Proposal #09: 6030-01-62, WISC 2018 173
STH 60 - Montello
USH 51 to STH 16
STH 22
Columbia County

This is Addendum No. 01, which provides for the following:

ADDENDUM NO. 01

6030-01-62

Addendum No. 01
 ID 6030-01-62
 Revised Sheet 58
 May 22, 2018

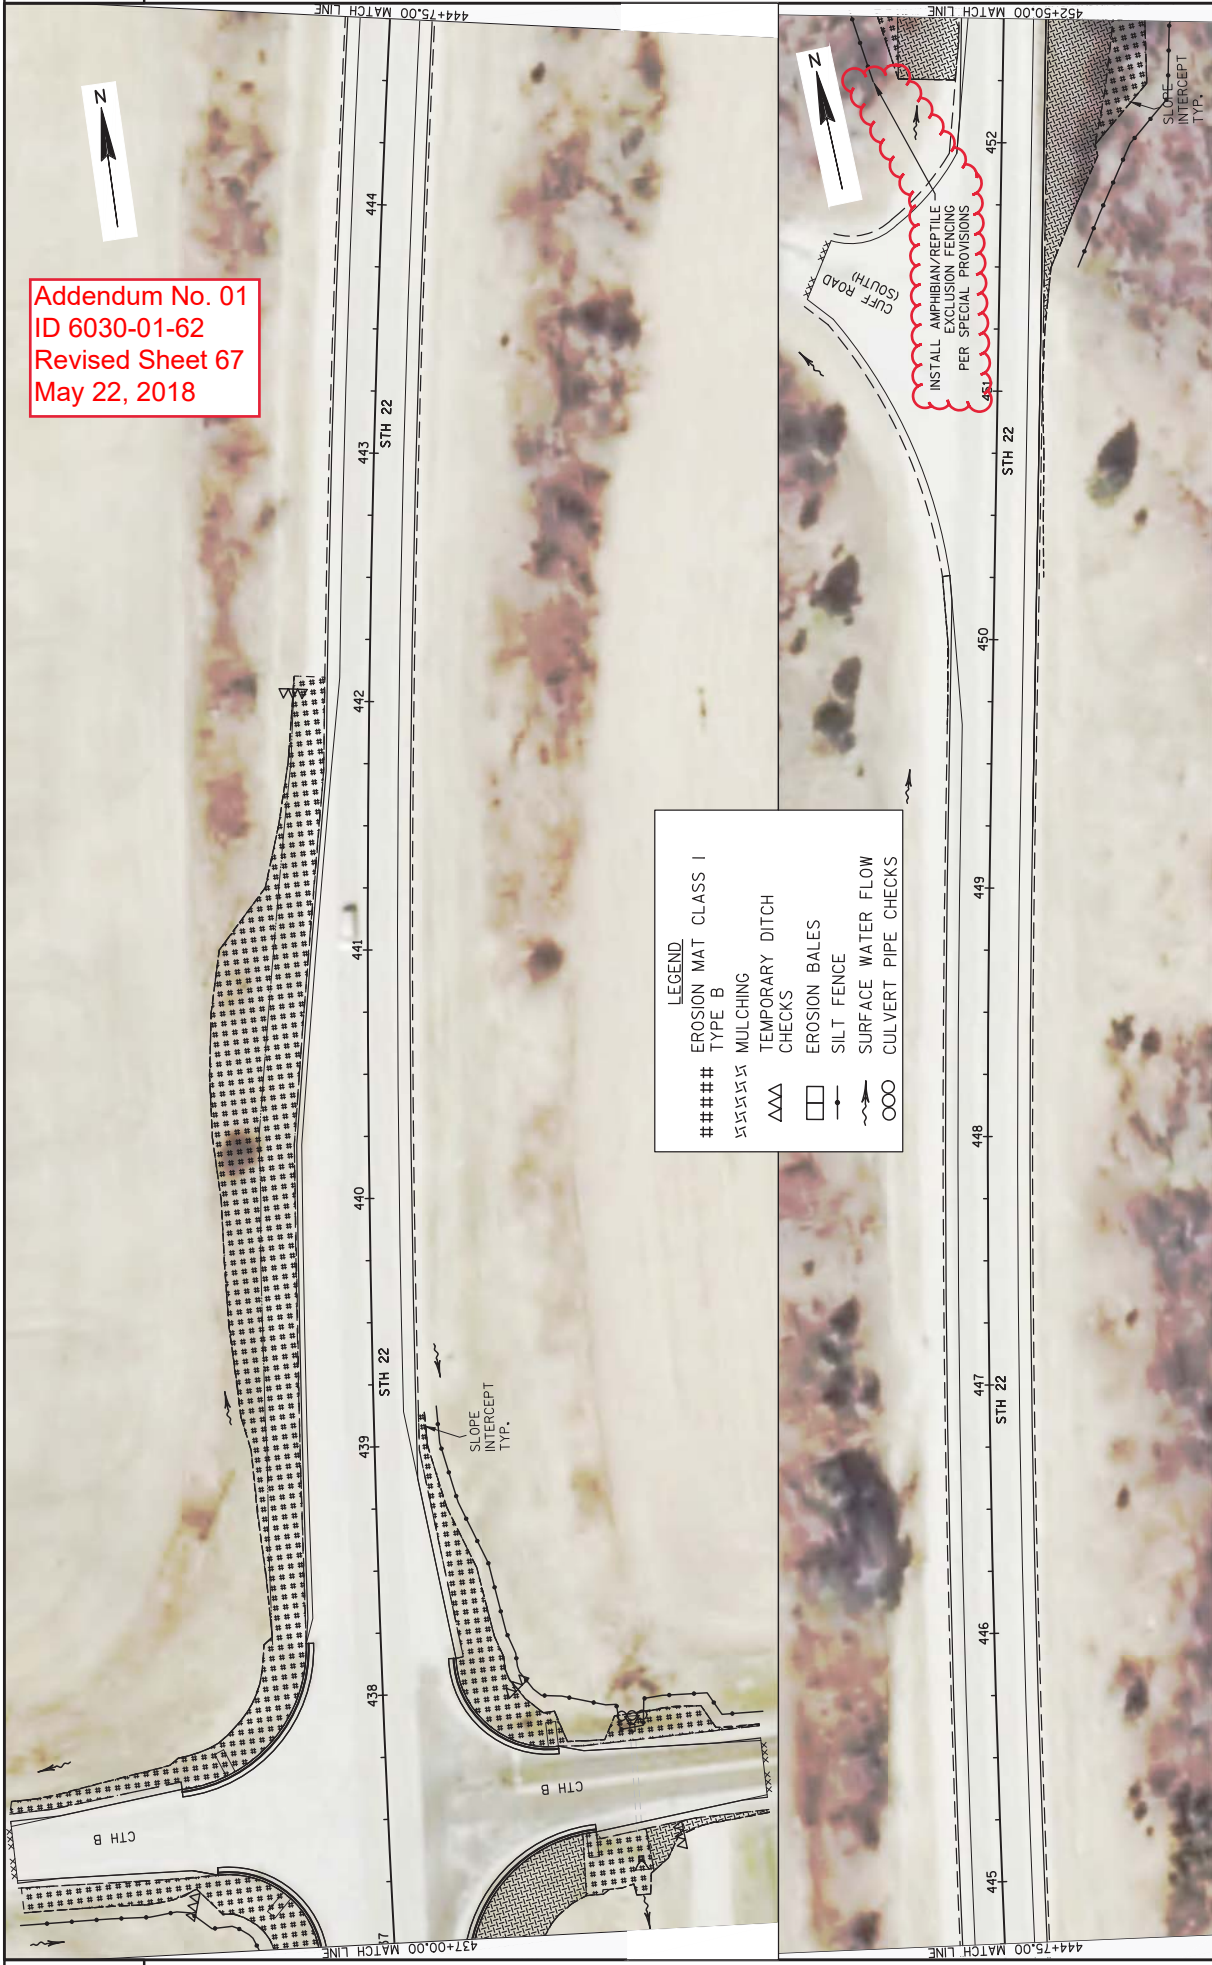
Revised Plan Sheets	
Plan Sheet	Plan Sheet Title (brief description of changes to sheet)
58	Erosion Control (added notes specifying locations requiring amphibian and reptile exclusion fencing)
67	Erosion Control (added notes specifying locations requiring amphibian and reptile exclusion fencing)
68	Erosion Control (added notes specifying locations requiring amphibian and reptile exclusion fencing)
69	Erosion Control (added notes specifying locations requiring amphibian and reptile exclusion fencing)
